Memo

From	James Griffiths, NIWA
To	Campbell Robertson, Bathurst Resources Ltd
CC	Eden Sinclair
Date	16 March 2021
Subject	Canterbury Coal Mine Closure – hydrology
Client Report No:	<i>2021053CH</i>

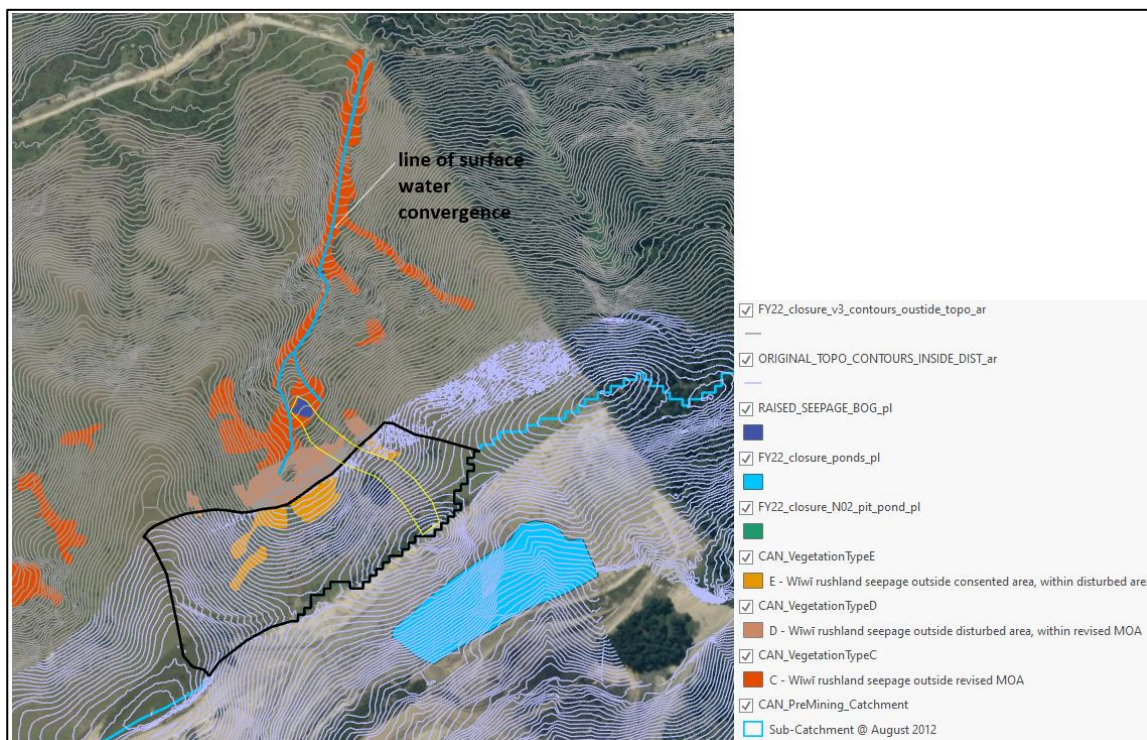
ECan: Under the new mine closure consent proposal, the quarried ridge on the northern margin of the mine operational area (MOA) will now not be reinstated (a change from previous proposal). How does the proposed final landform influence the hydrology of the seepages and spring on the NW slopes outside of the MOA? The previous assessment by “Jens Rekker”, in his “December 2019 Response on Hydrological Matters”, stated that ‘The rehabilitated final landform will restore the pre-existing shallow, downslope seepage’.

As pointed out at meeting last week by Ecan groundwater hydrologist Fouad Alkhaier, this will have implications for hydrology (water supply) to springs and seepage wetlands on the hillslope north of the current MOA. Hydrological impacts will have flow-on effects on seepage wetland ecology. These hydrological and ecological effects need to be assessed, and measures proposed to manage impacts on affected wetland areas.

In Figure 1, the line of surface water flow convergence (shown as blue line) has been derived from surface topographic contours. The raised spring area (purple), lies just outside this line. The surface water contributing area itself is seen to be relatively small (shown as yellow line). This suggests that the raised spring is fed by predominantly sub-surface rather than surface water drainage.

Figure 5: Final landform drainage patterns (map provided by Bathurst).

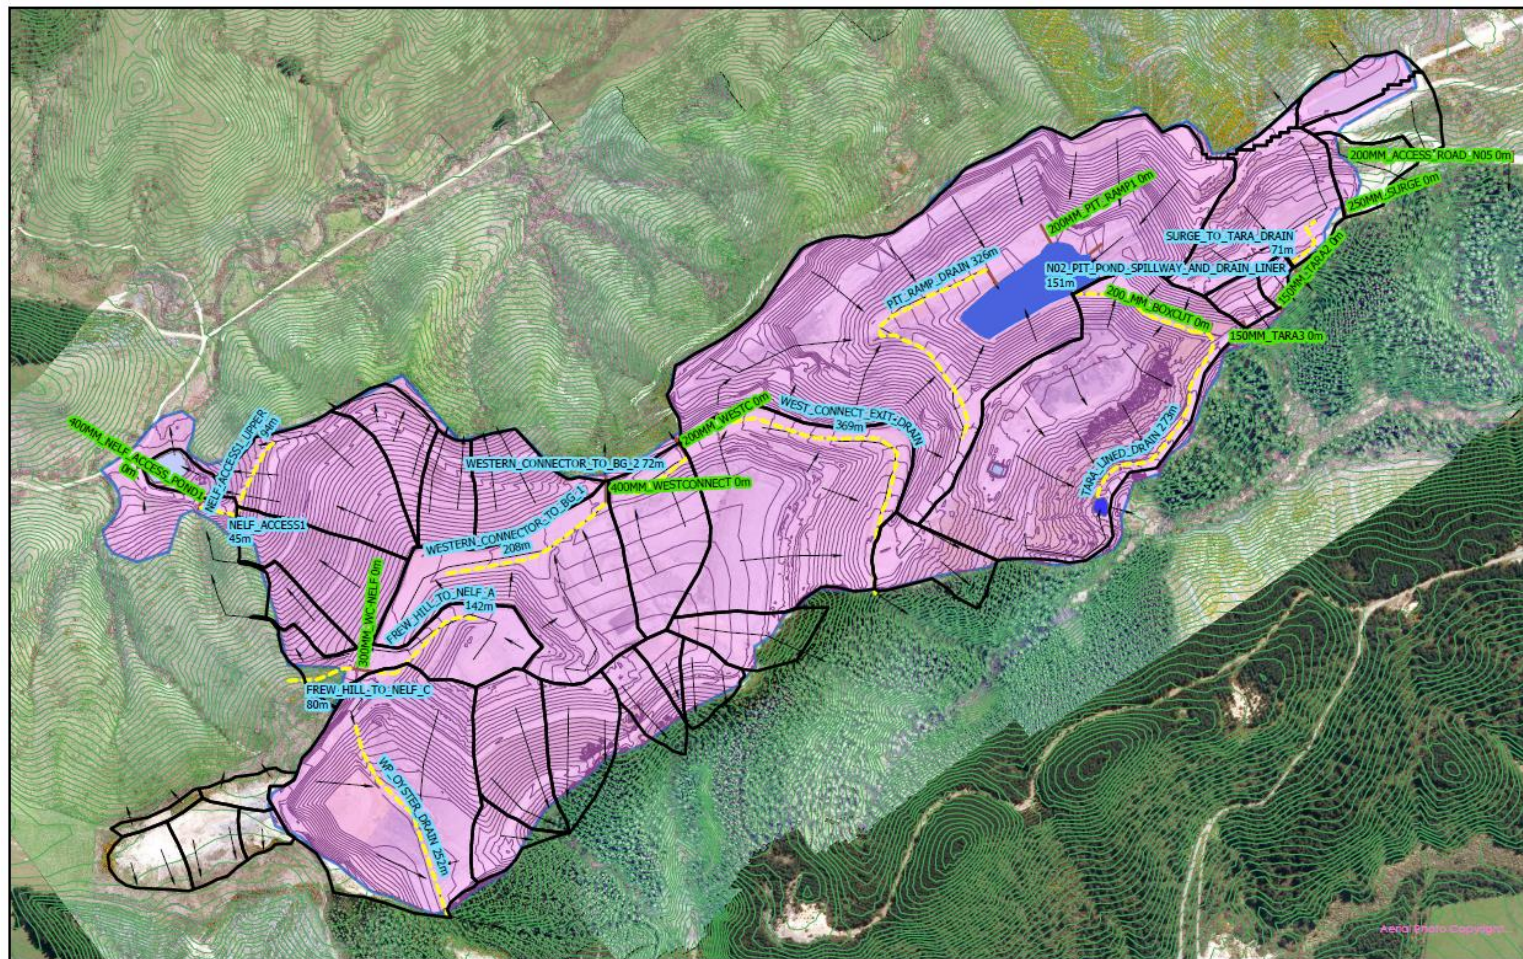
In addition to the overall changes in sub-catchment areas, the final landform will include a new pond feature which will capture some water, rather than the slope being reinstated to shed water. Some assessment of how this influences the hydrology of the Tara wetland/stream is necessary.

The impact of the No2 pit pond, spillway and drainage channel (shown in Figure 5) will be to buffer surface water runoff, i.e., reduce peak runoff but sustain low flows (to an extent determined by the spillway threshold). It is envisaged that the spill level of the No2 pond could be managed with the lower Tara pond to ensure minimum low flows to the Tara catchment are sustained.
